UNITED STATES PATENT AND TRADEMARK OFFICE

APPLICATION NO.	FILING DATE	FIRST NAMED INVENTOR	ATTORNEY DOCKET NO.	CONFIRMATION NO.
10/008,623	12/06/2001	Malcolm R. Schuler	90065.161701	3753

Office Action Summary

DETAILED ACTION

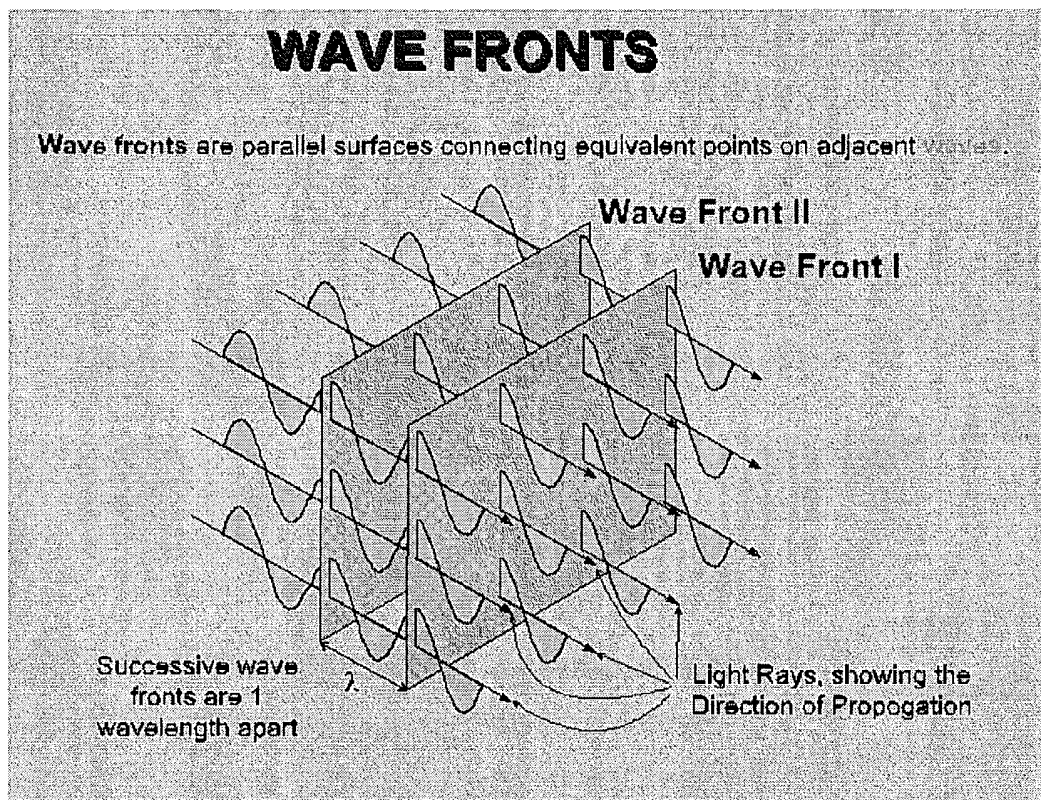
For better visual presentation the definition of the term from

<http://www.brocku.ca/earthsciences/people/gfinn/optical/wavefron.htm> is presented here:

1. Wave front - parallel surface connecting similar or equivalent points on adjacent waves.
2. Wave Normal - a line perpendicular to the wave front, representing the direction the wave is moving.
3. Light Ray is the direction of propagation of the light energy.

The applicant's attention is directed to the fact that any direction, which would be perpendicular to the direction of travel of the waves (Direction of Propagation on the Figure), would be in the surface defined as Wave Front. Thereby, there is no a direction which is at the same time perpendicular to the direction of travel waves and to the wave fronts.
